Site Instruction

SI 20

PROJECT : **Hampton Manor**
PROJECT No : 1136.13
DATE : June 14, 2018

Title: Mechanical Floor Precast Update

1:100 A308a

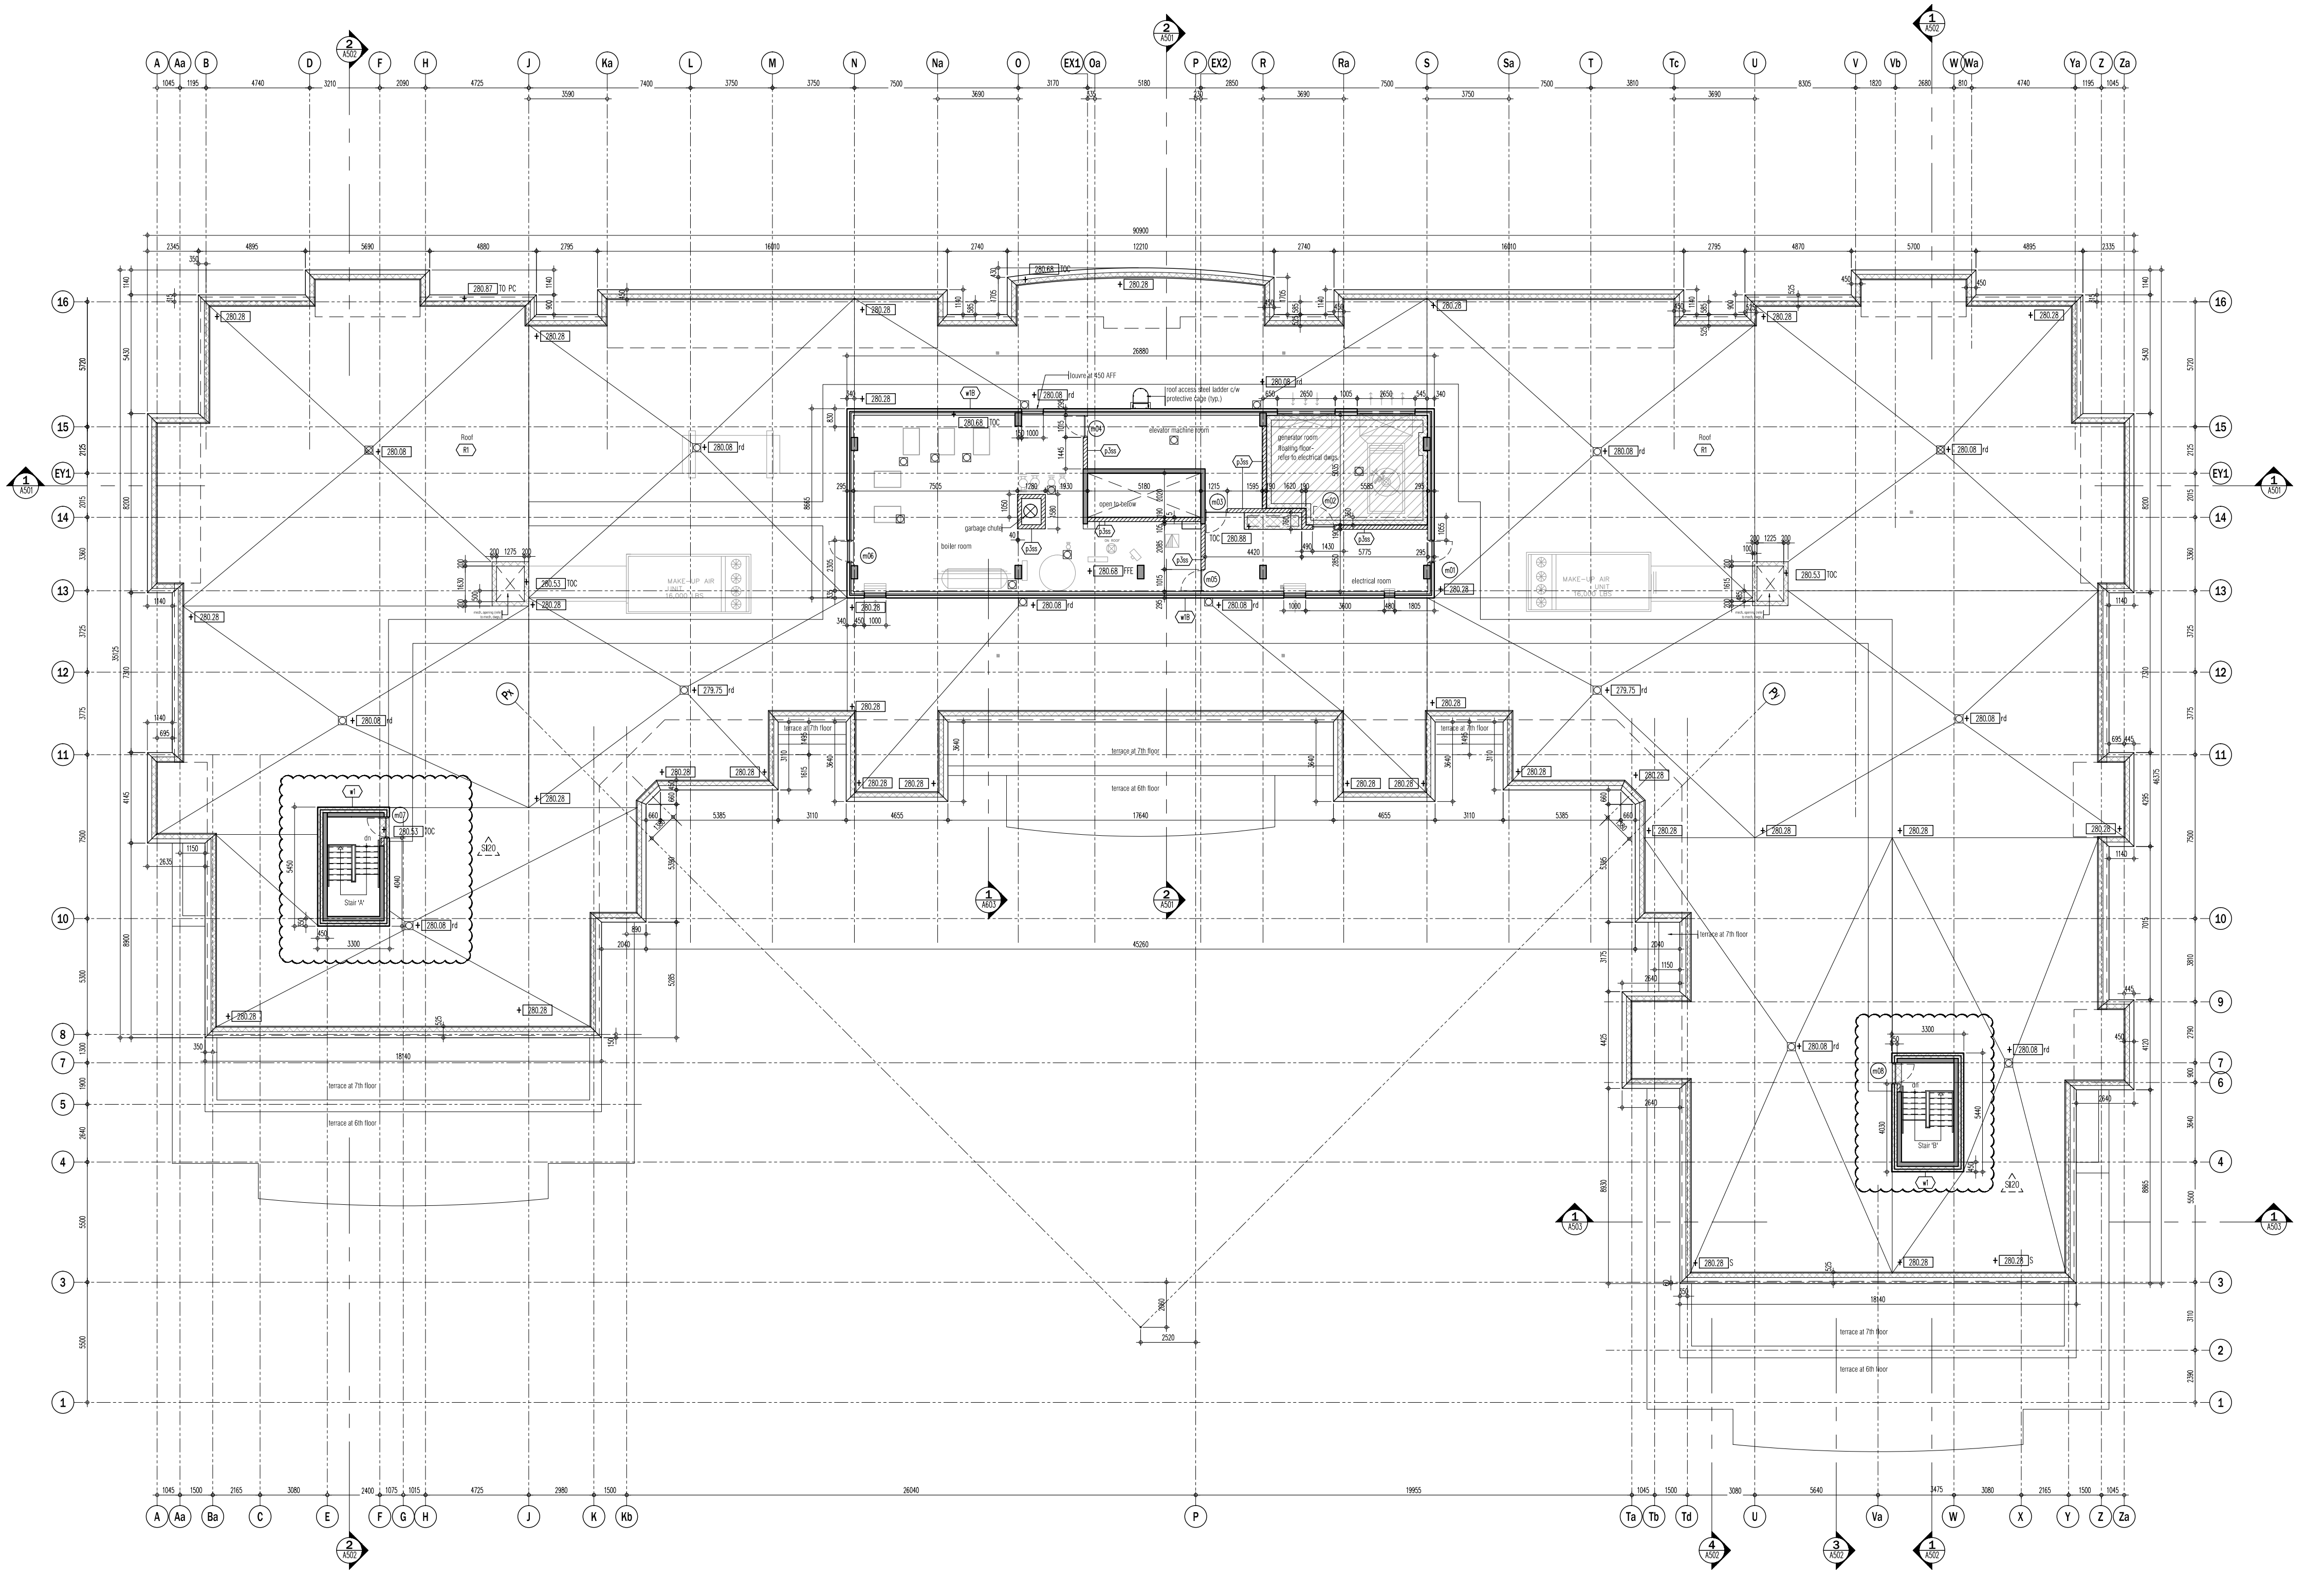
A308a, A308b – Roof Plan
- Revising spandrel cladding to precast at stair A & B.

1:100 A401a

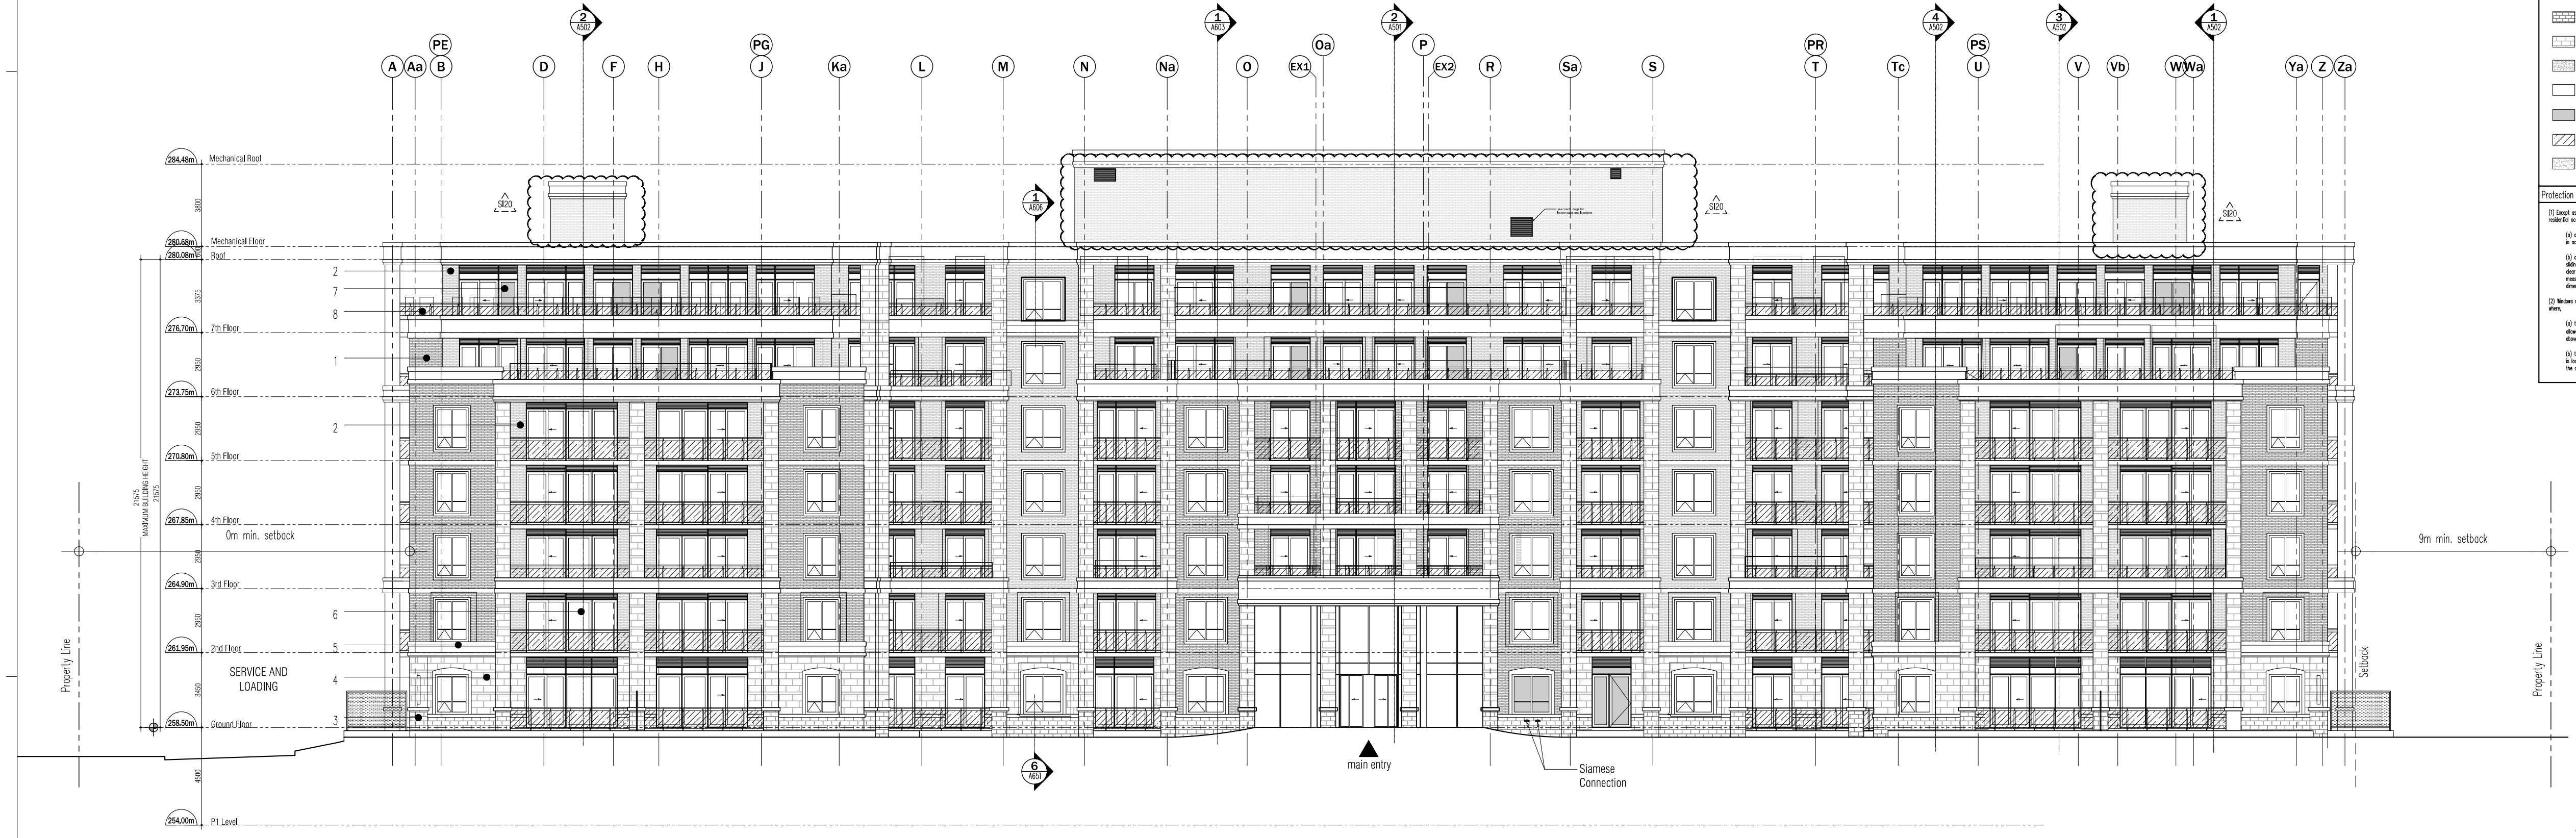
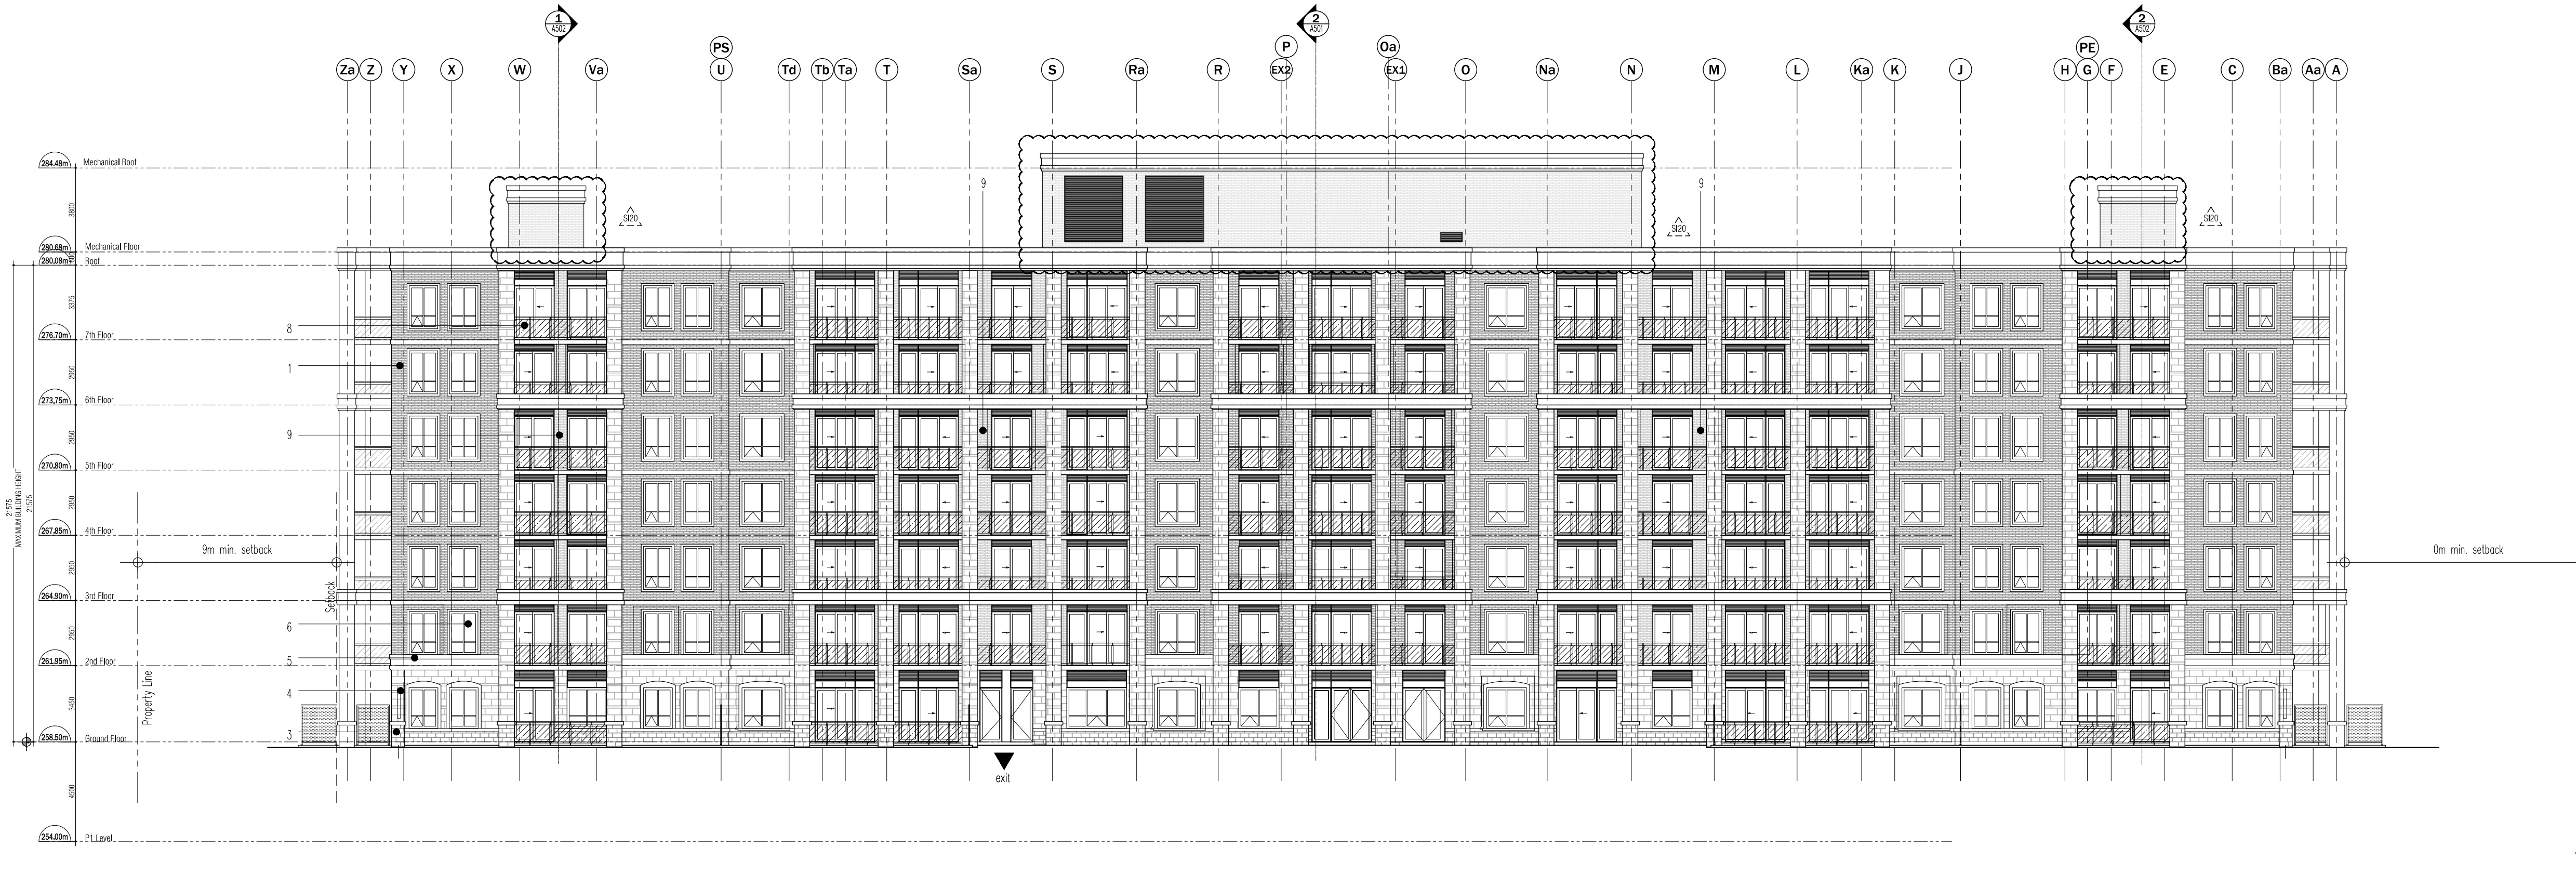
A401a, A401b, A401c – Building Elevations
- Showing louvers on Mechanical Penthouse and revising spandrel cladding to precast at stair A & B.
